RE: Request for Approval of the Clews Subdivision located at 799 South Street, Tax Map 132 / Lot 24

On behalf of the Noele M. Clews Revocable Trust we hereby submit a request for Subdivision Approval at 799 South Street. The project team met with the Technical Advisory Committee on July 2, 2019 to review the proposal. The Technical Advisory Committee voted to recommend Preliminary and Final Subdivision Approval with the stipulations listed herein. Responses to the stipulations are highlighted in **Bold Text**:

CLEWS SUBDIVISION
799 SOUTH STREET
PORTSMOUTH, N.H.

DRIVEWAY PLAN

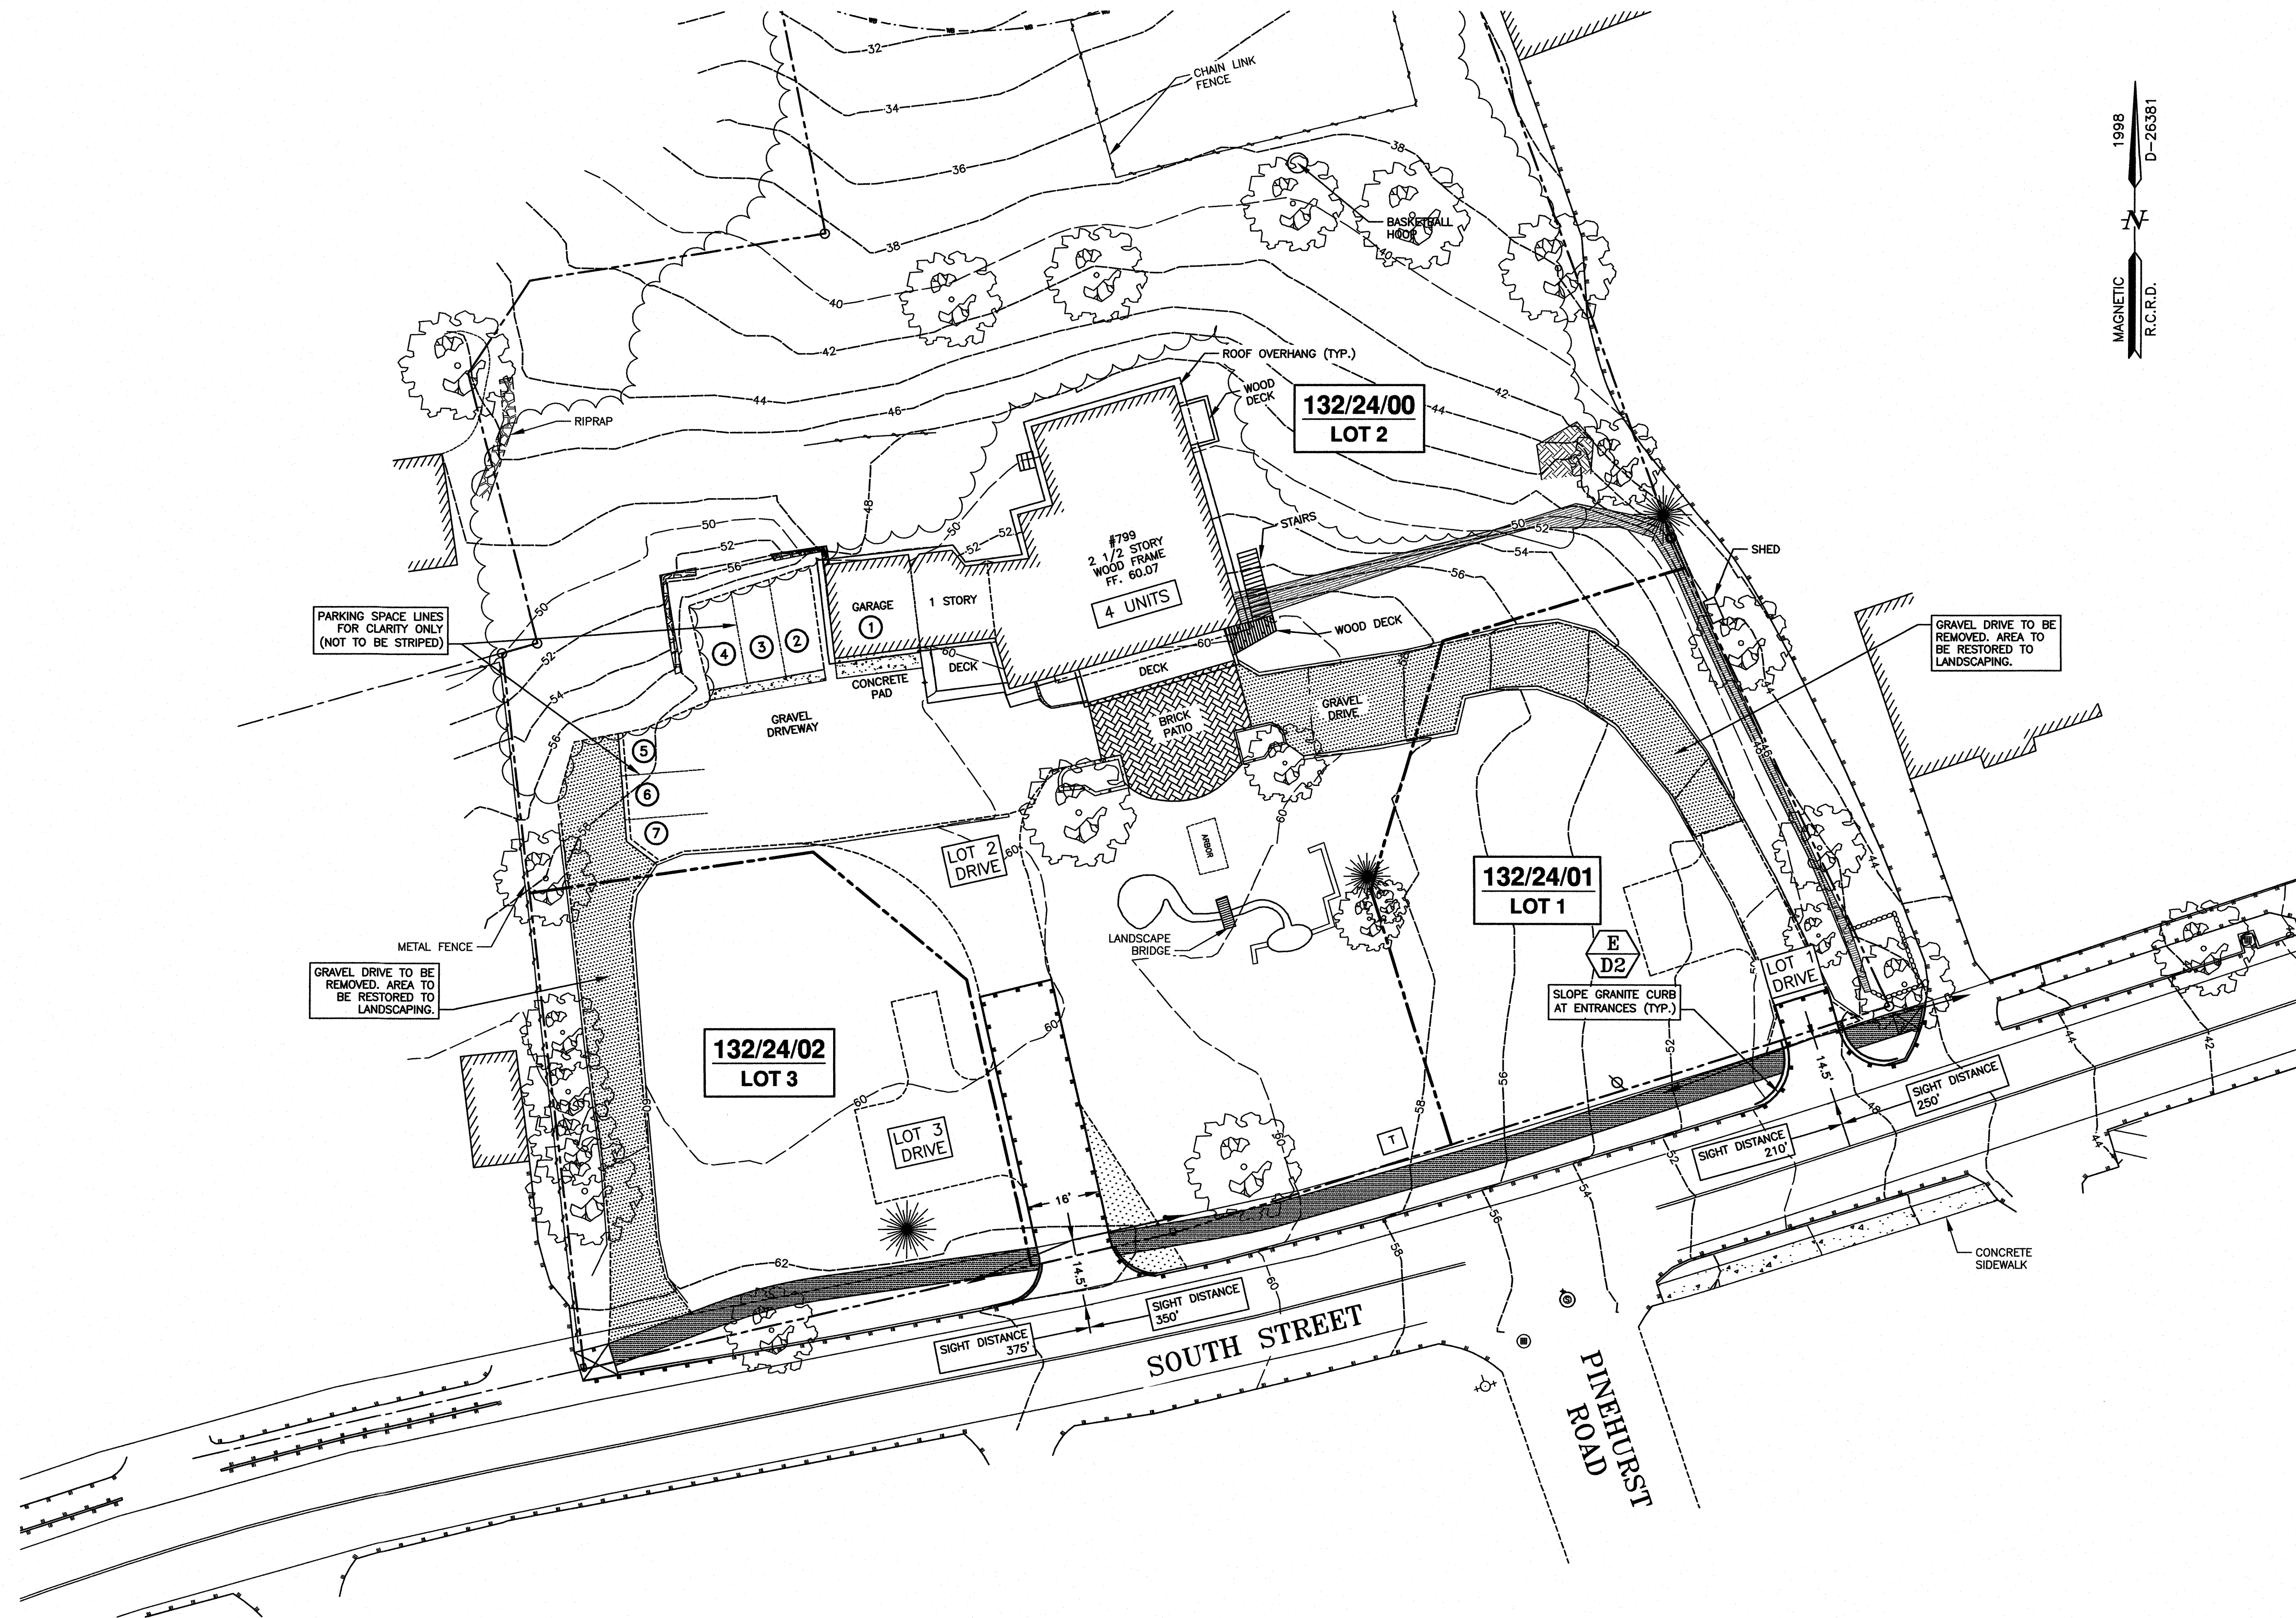
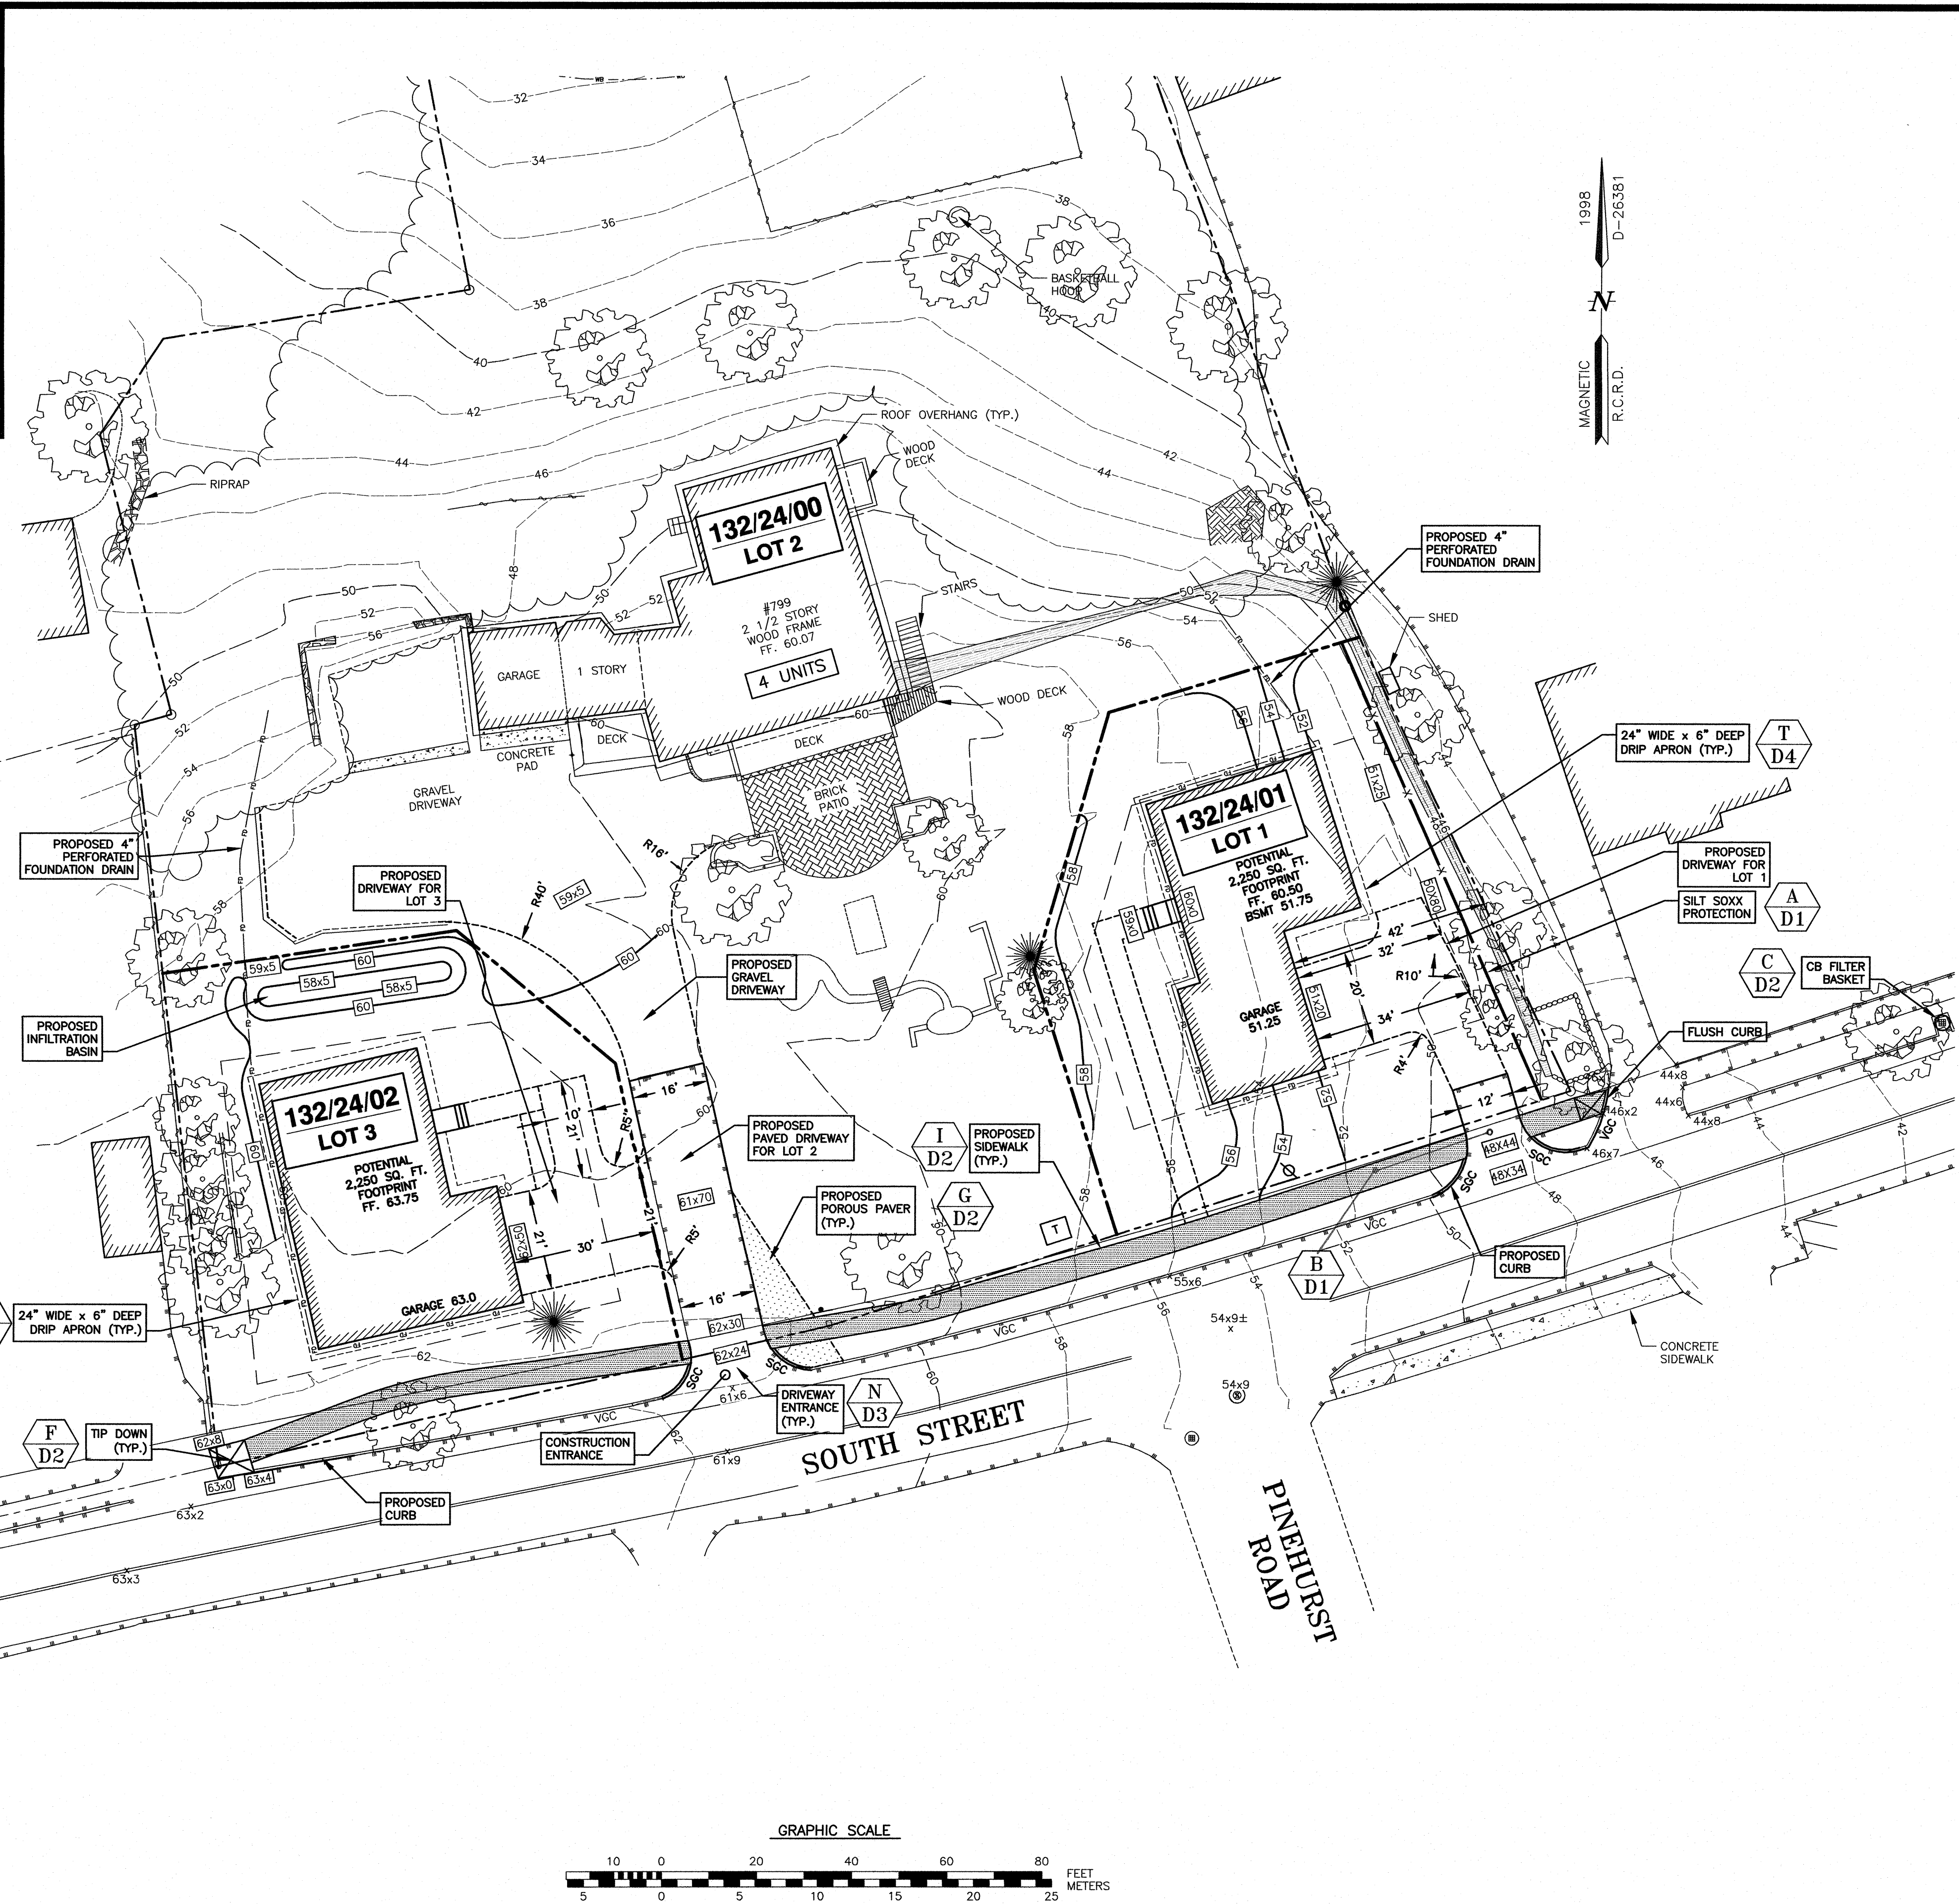
2. The sight distances in both directions at each driveway should be verified on a profile plan of the roadway to be reviewed and confirmed by Eric Eby, the City's Transportation and Parking Engineer. **Site distance profiles have been provided in the plan revised plan set. After review, the driveway location for Lot 1 was relocated to the existing lower driveway. The plans now show that we have adequate driveway site distance in both directions at both driveways. We have followed up with the Parking and Transportation Engineer, Eric Eby, and attached his email stating that he is satisfied that the site distance requirements have been met.**

Thank you for the plans. After reviewing both of the sheets, I am satisfied that the minimum sight line requirements will be met at the Lot 1 Driveway. Let me know if you need anything else from me.
